TO: Mayor Keisha Lance Bottoms
ATTN TO: Monique Forte, Urban Planner III
FROM: Douglas R. Hooker, Executive Director
RE: Development of Regional Impact (DRI) Review

Name of Proposal: Bolton Mixed Use (DRI #3097)

Review Type: Development of Regional Impact **Date Opened:** July 27, 2020 **Date Closed:** August 13, 2020

BOLTON MIXED USE DRI
City of Atlanta
Natural Resources Group Review Comments
June 30, 2020

A SITE PLAN
P-1 SCALE: 1"=40'

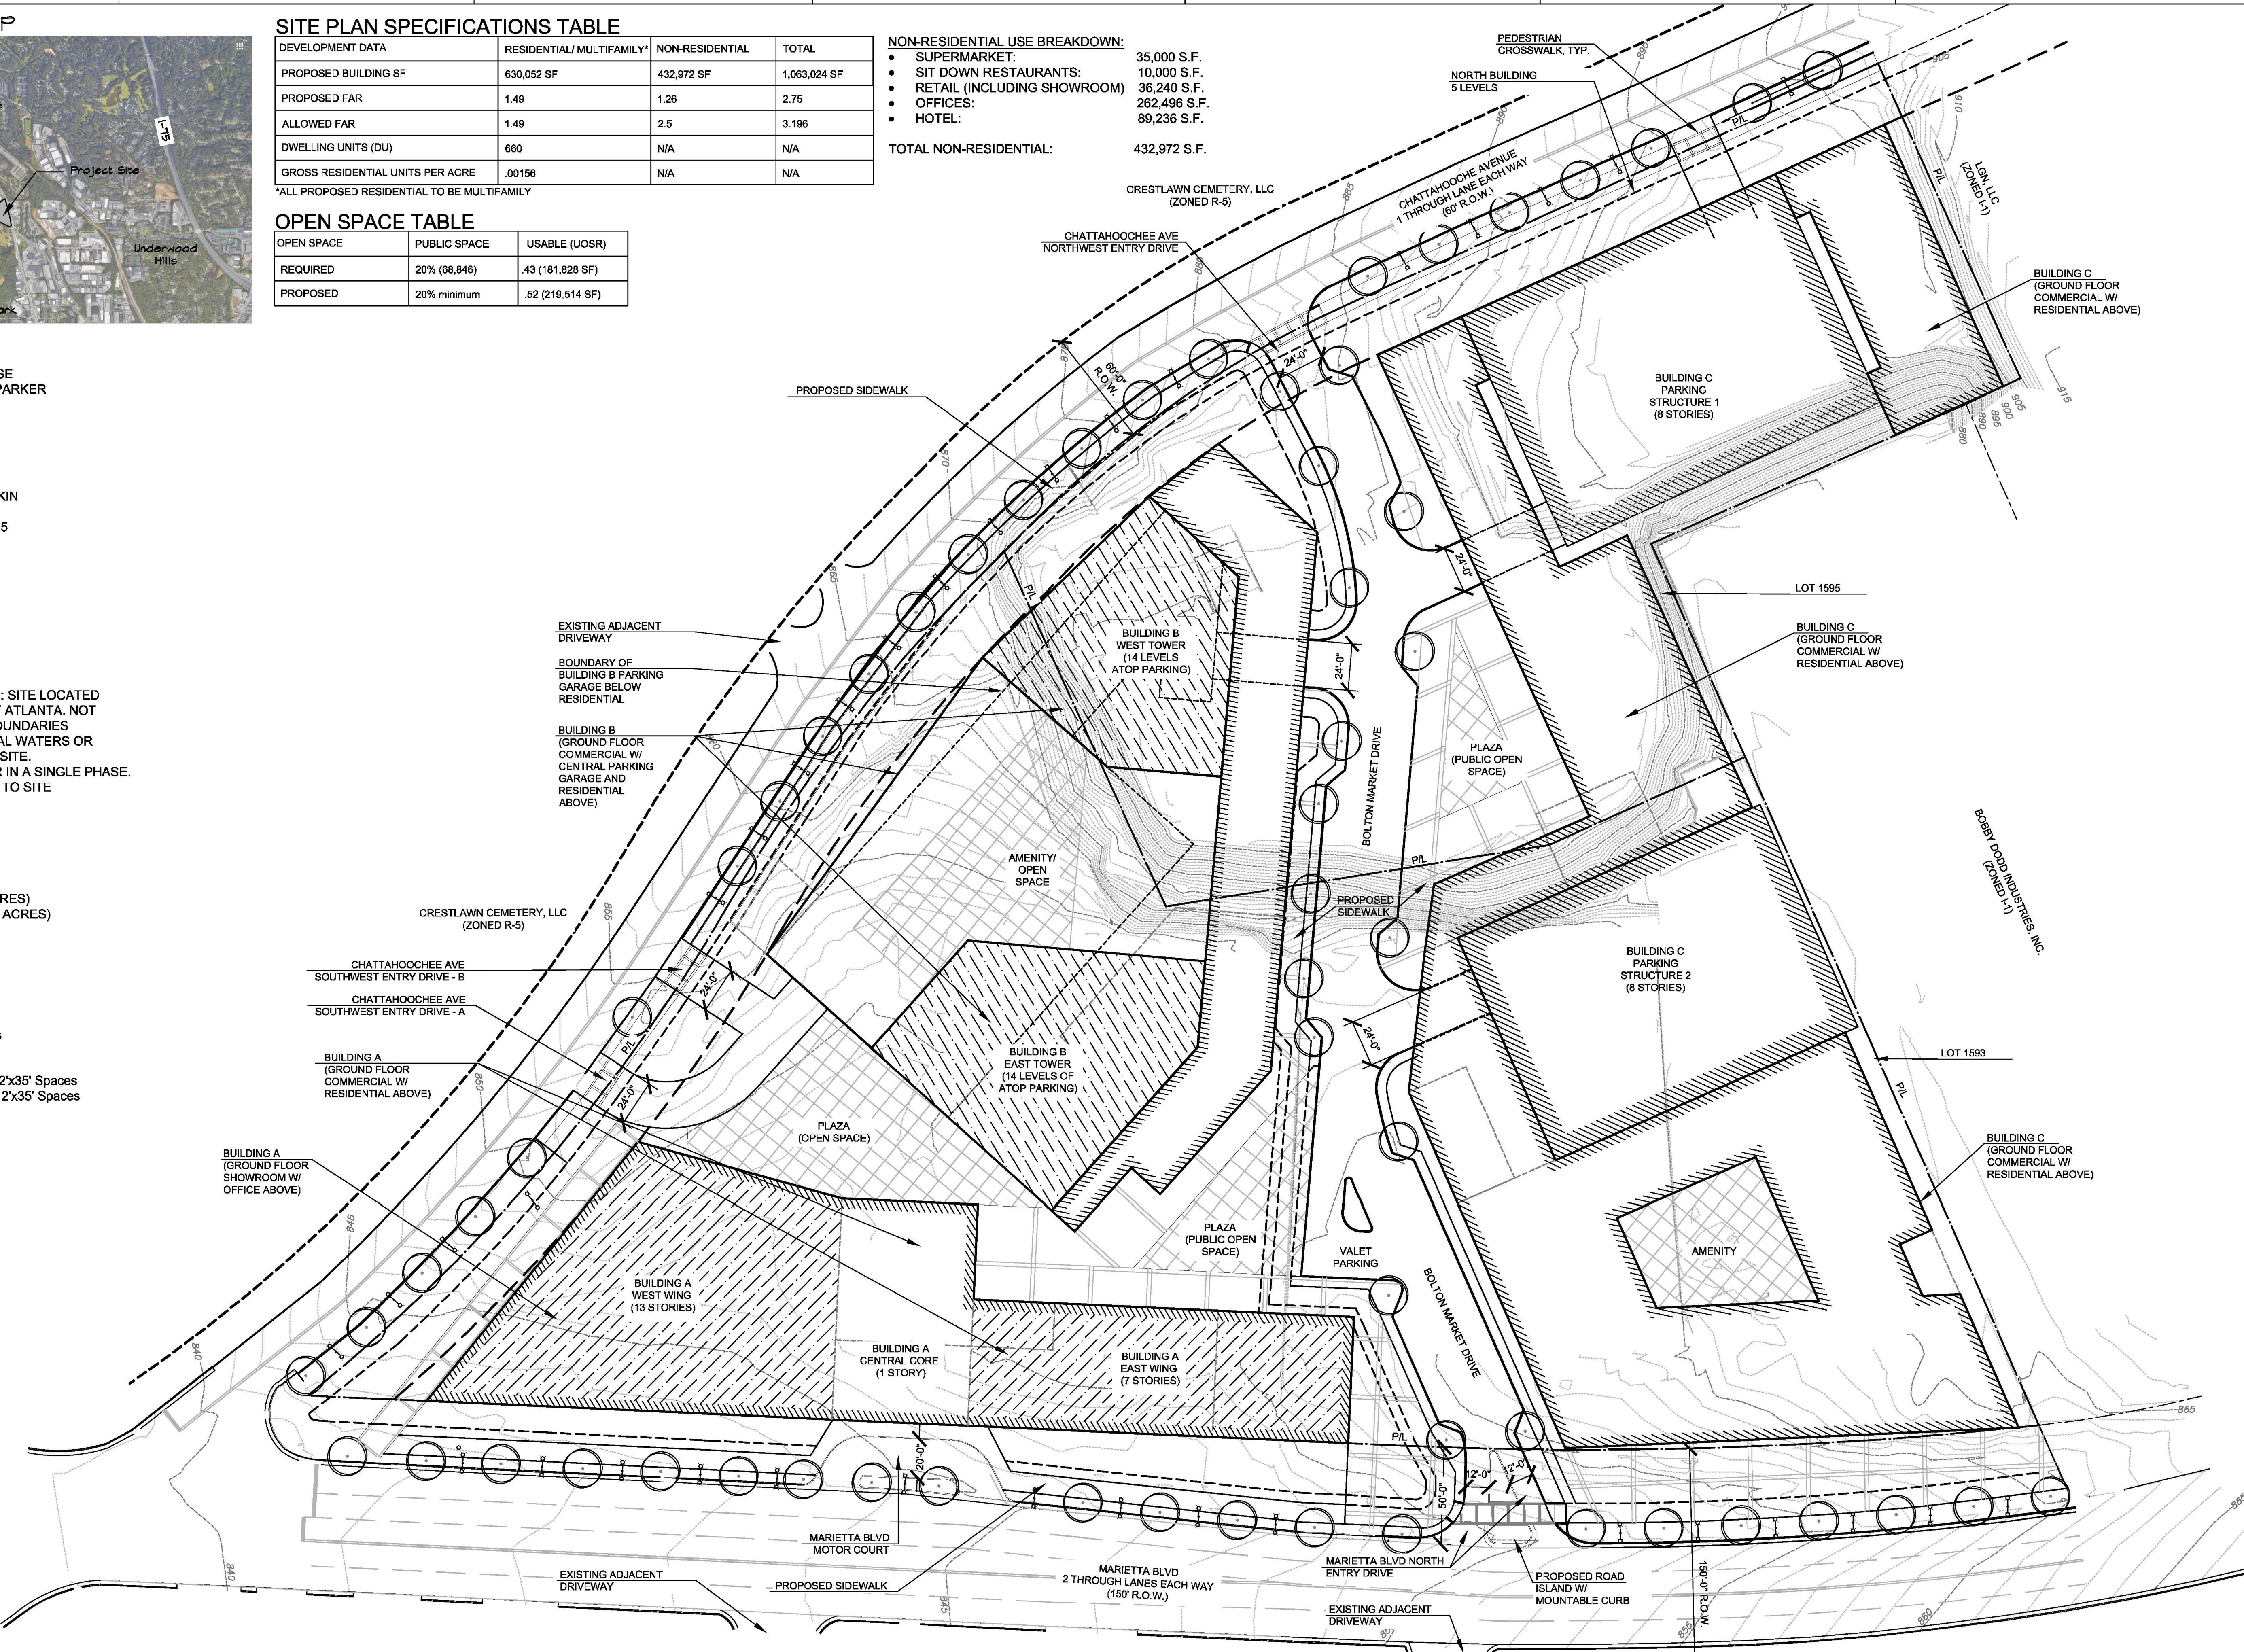
During the Pre-Review meeting on April 22, 2020, there was discussion about whether two driveways (Southwest Entry Drives A & B) on the Chattahoochee Avenue side were necessary because they are close together and introduce unnecessary pedestrian conflicts. The submitted site plan still shows these two driveways, but further analysis should consider whether the access can be accomplished with one. There was also discussion about the motor court shown on Marietta Boulevard, which can be useful for ride-hailing services, but has the potential to intrude on the pedestrian space. The driveway should be designed in such a way that prevents drivers from exiting Marietta Boulevard at high speed and maintains ample ADA-accessible passage for pedestrians. Additional comments from ARC's Transportation Access & Mobility Group and GDOT's aviation division are attached.

The project could further support The Atlanta Region's Plan in general if it incorporated other aspects of regional policy, including green infrastructure and/or low-impact design (e.g., rain gardens, vegetated swales, etc.) in parking areas and site driveways, and as part of any improvements to site frontages. There appear to be many opportunities for incorporating this infrastructure in the projects public plazas and internal street.

Proposed building abut adjacent parcels prohibiting inter parcel connectivity. Adjacent parcels can be accessed from local roads.

The site plan depicts pedestrian facilities adjacent and internal to the site.

The site plan depicts proposed sidewalks internal and adjacent to the proposed site.
